Modification Statement regarding application for Permissive to Change of
 FCC ID: PH7VZ1- 3DWCB -B

Date : Sept. 16, 2003

For FCC 15.247 PCII

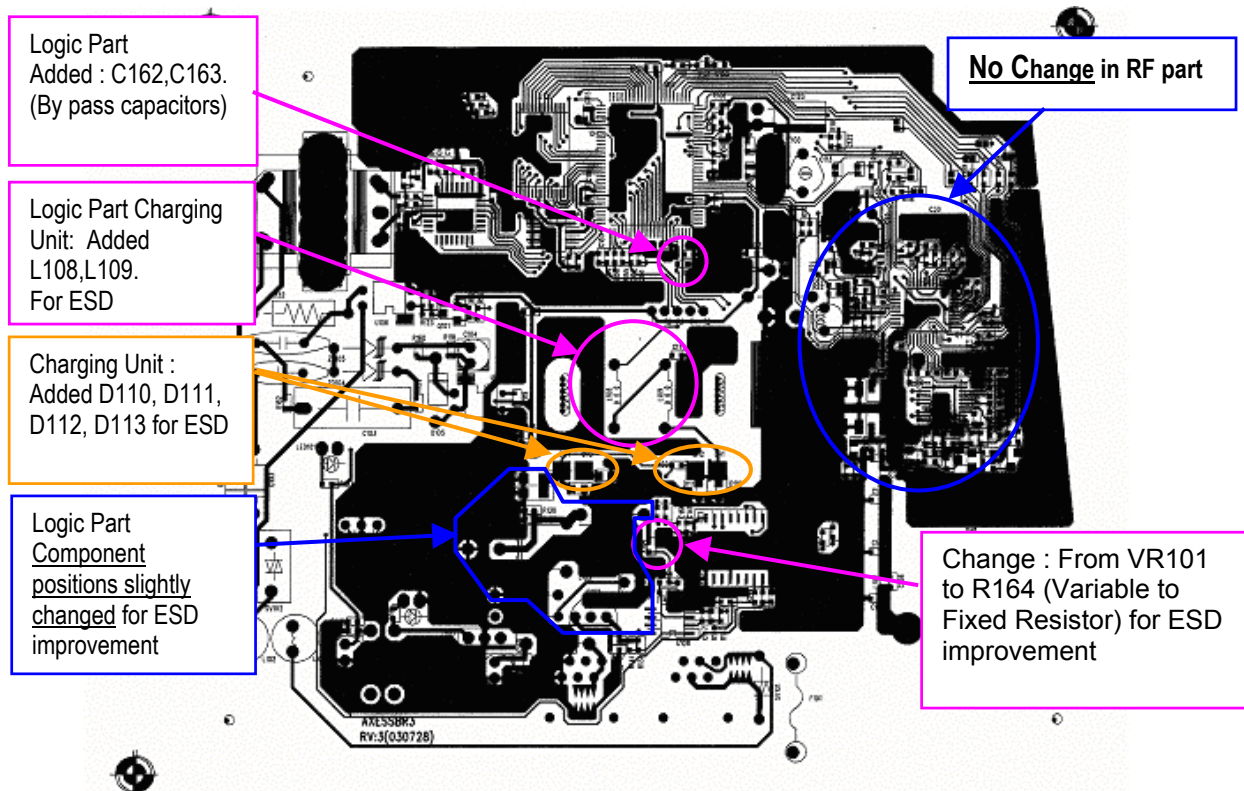
Item	Part	Purpose	Revision	Remark
ESD Diode	Base Charge	ESD improvement	D110, D111, D112, D113	Add
Coil	Base Charge	ESD improvement	L108, L109 1mH Bulk Type	Add
Chip Cap'	Base Logic	By pass capacitor	C162, C163 100pF	Add

2. Layout change due to the component addition and for ESD (Electric Shock Damage) improvement is as in the following diagram.
